**UNITED STATES OF AMERICA
BEFORE THE
FEDERAL ENERGY REGULATORY COMMISSION**

**PETITION OF THE NORTH AMERICAN ELECTRIC RELIABILITY CORPORATION
FOR APPROVAL OF A NEW TERM “INVERTER-BASED RESOURCE” USED IN
NERC RELIABILITY STANDARDS**

November 4, 2024

Figure 2.1 Example diagram of an IBR depicting the IBR (red box), collector system (green box), and IBR Units (blue boxes)

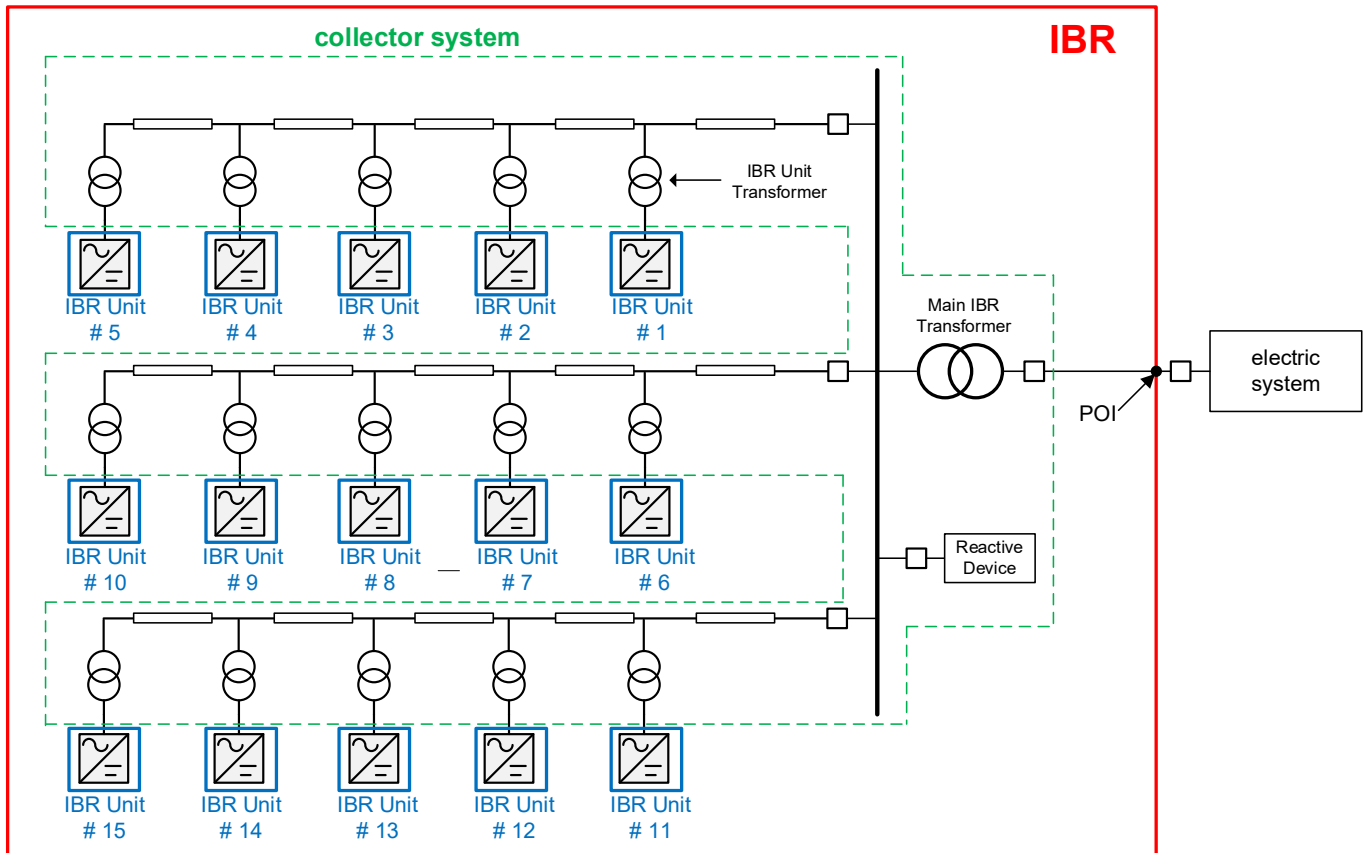
Second, the SDT should consider the compatibility of the proposed IBR definition, as depicted in Figure 2.1 of the Technical Rational with the existing BES definition, I4 inclusion. The definition does not include the collection system (below 75MVA) in the scope of the parts of a facility.
